ADDENDUM NO. 1

PROJECT: Sam Collins Park Phase 1B

BID NO.: RFB 25-1203

FROM: Kristina Malek
Project Manager – Landscape Architecture
Kimley-Horn
11700 Katy Fwy, Suite 800
Houston, Texas 77079

SHEET NUMBER
L3.03

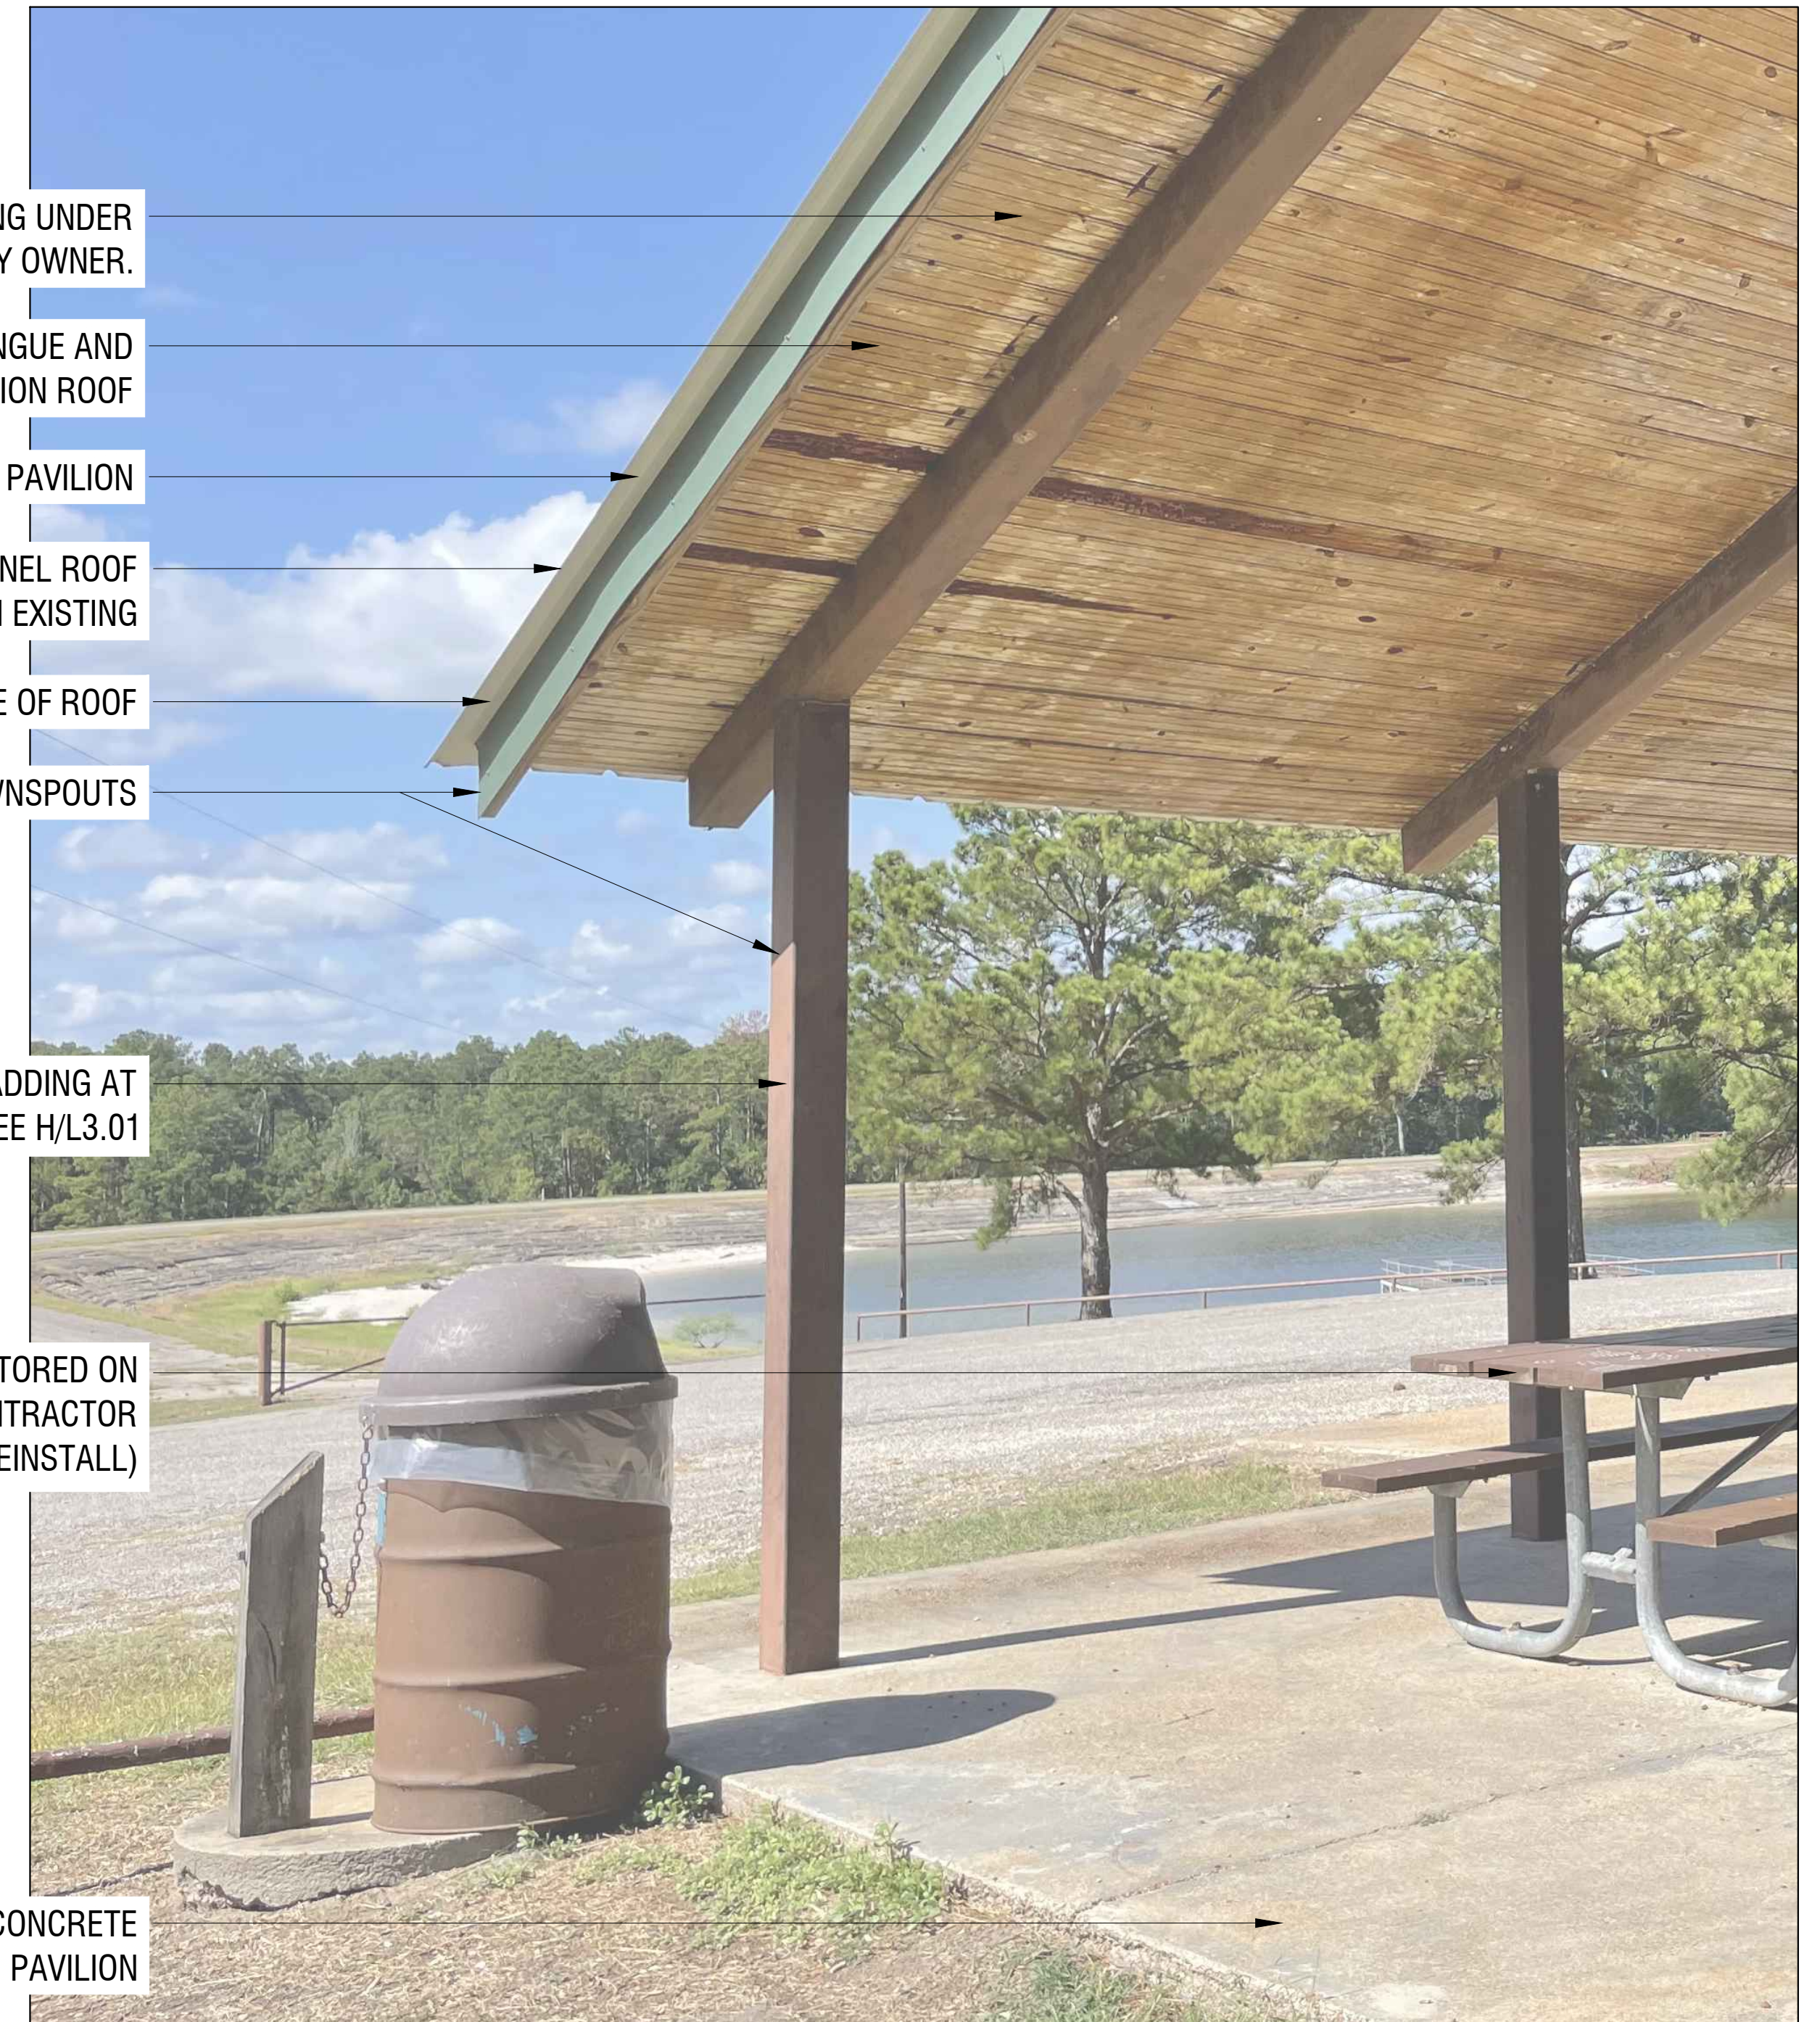
6. Question: Pavilion – specify the 1” x 6” tongue and groove panels

9. Question: Once removed, the picnic tables shall be stored on site for Owner’s use (do not re-install)

Response: Note revised to include 1” x 6” on sheet G0.02 and L3.03

Response: Note added on sheet L3.03 and G0.02.
